Staff Report

Dillon Urgent Care and Residences

PUD Development Plan

**Prepared by the
Town of Dillon for the
Planning and Zoning Commission**

Figure 2: Base Elevation Calculation

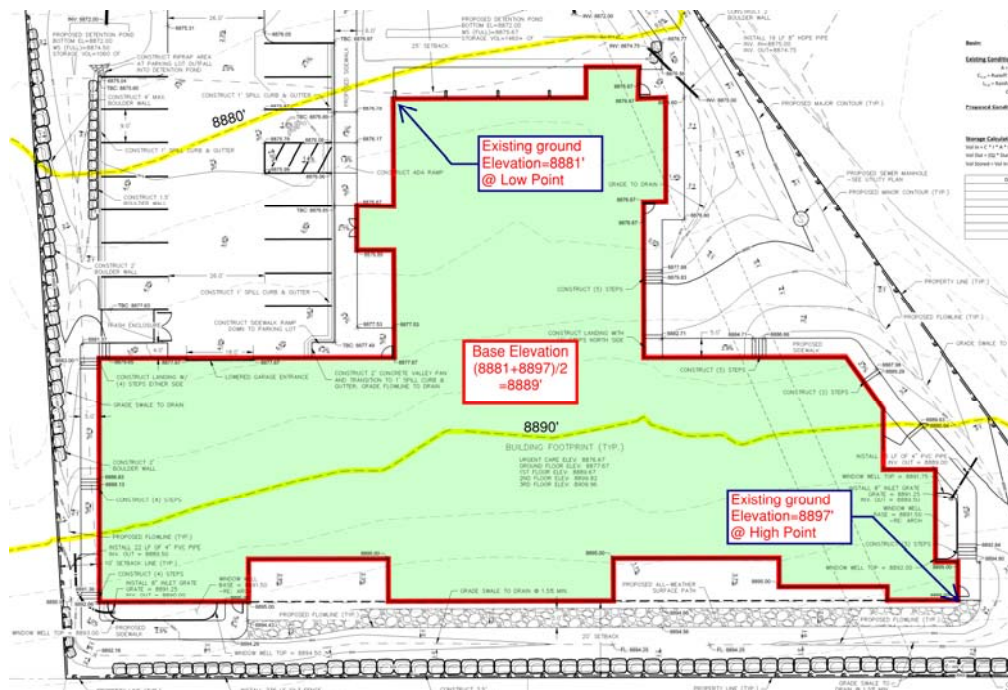
The maximum height of the proposed physical building's elevator tower is calculated at an elevation of 8,929.72'. The mixed Use (MU) Zone District allows buildings to have a maximum height of 35' as measured per Town Code, plus an additional 8' for uninhabited structures such as the tops of elevator towers. The base elevation was determined to be 8,889' so the maximum allowable height is 43' (35'+8') higher or 8,932'. See the Figure below to see how the base elevation was calculate.

The proposed building is under the allowable height for the building by 2.28'

Figure: Existing Sewer Easement to be Vacated

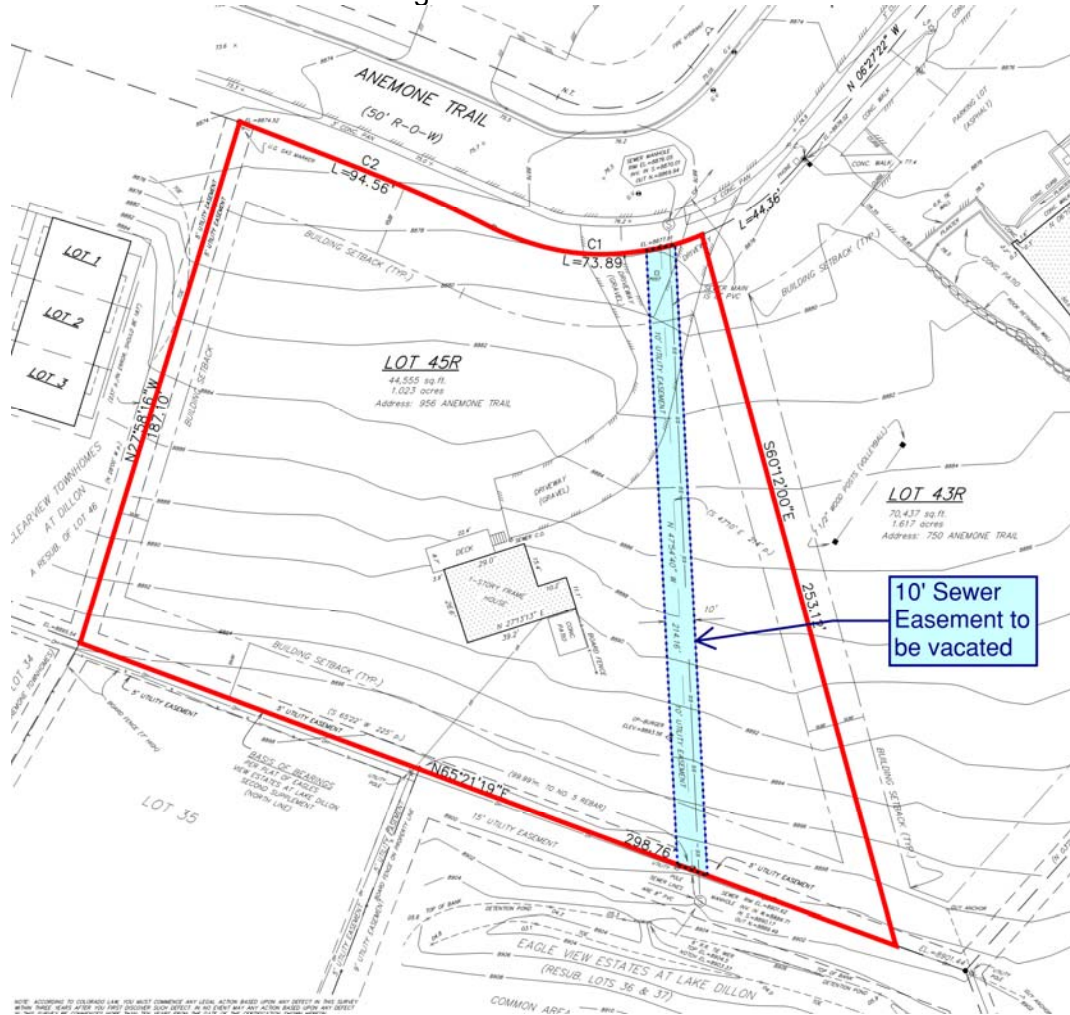
An existing sanitary sewer main runs through the north end of the site within an existing 10' easement. This application proposed moving the sanitary sewer main to the north side of the lot and dedicate a new 20' utility easement to the Town. The Figure below indicates the location of the existing easement.
